GENERAL REGULATIONS

SECTION 301
GENERAL**301.3 Connections to the sanitary drainage system.**

DRAINAGE PIPE PLACED UNDER EXISTING FOOTING
FIGURE 3-6

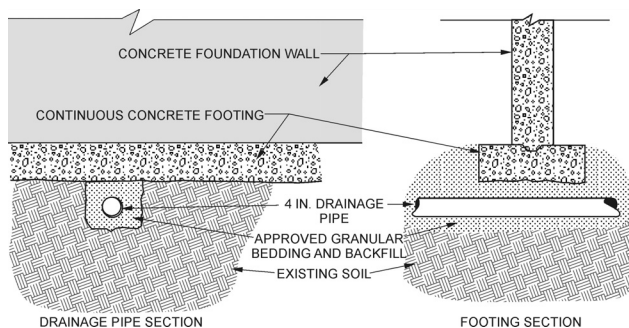
Q• Is engineering required for excavating and installing plumbing pipes under a footing that is already in place? The piping is perpendicular to the footing. I'm not sure I understand the intent of IPC

Sections 305.5 and 307.5 and what level of protection is required for the piping.

A•The intent of Section 305.5 is to ensure that structural loads of the building foundation are not placed on the pipe. Digging under an existing concrete footing for installing a pipe perpendicular to the footing is common practice. Assuming the footing is continuous, as opposed to isolated, typical footing design permits bridging over a small excavation without transferring loads to the pipe. Backfill should be appropriate material, such as crushed stone or sand. Installation of a 4-inch pipe under a typical continuous footing can be accomplished without engineering or additional protection of the pipe. For larger excavations or unusual conditions, the building designer and contractor should be consulted for an appropriate design to maintain the structural integrity of the footing and prevent structural loads from being transferred to the pipe. Section 307.5 protects the structural integrity of the footing from excavations that are parallel and below the bearing plane of the footing and does not apply to an installation that is perpendicular. See Figure 3-6. [3-6]

PIPE PASSING THROUGH FOUNDATION WALL
FIGURE 3-7

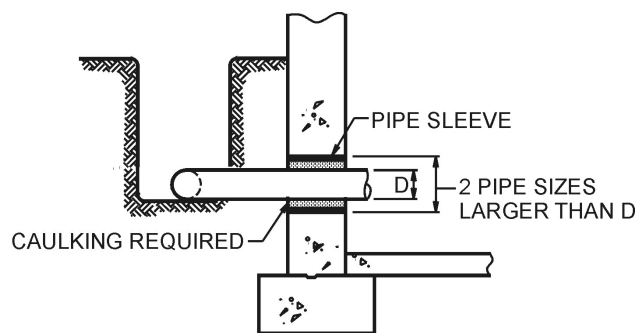
Q•Does a rubber gasket (doughnut) manufactured in accordance with ASTM-443, ASTM-361, and ASTM-923 meet the intent of Section 305.5 for providing relief from the transfer of structural loading where a Schedule 40 PVC sewer pipe penetrates a concrete foundation wall? The gaskets serve to seal the penetration from moisture and provide separation between the penetrating piping and the concrete structure that surrounds it.

A•No. Section 305.5 requires a sleeve two pipe sizes greater than the pipe passing through the foundation wall. The tight-fitting gasket does not prevent transfer of possible stresses to the pipe. A gasket is not considered equivalent to a relieving arch or pipe sleeve. See Figure 3-7. [3-7]
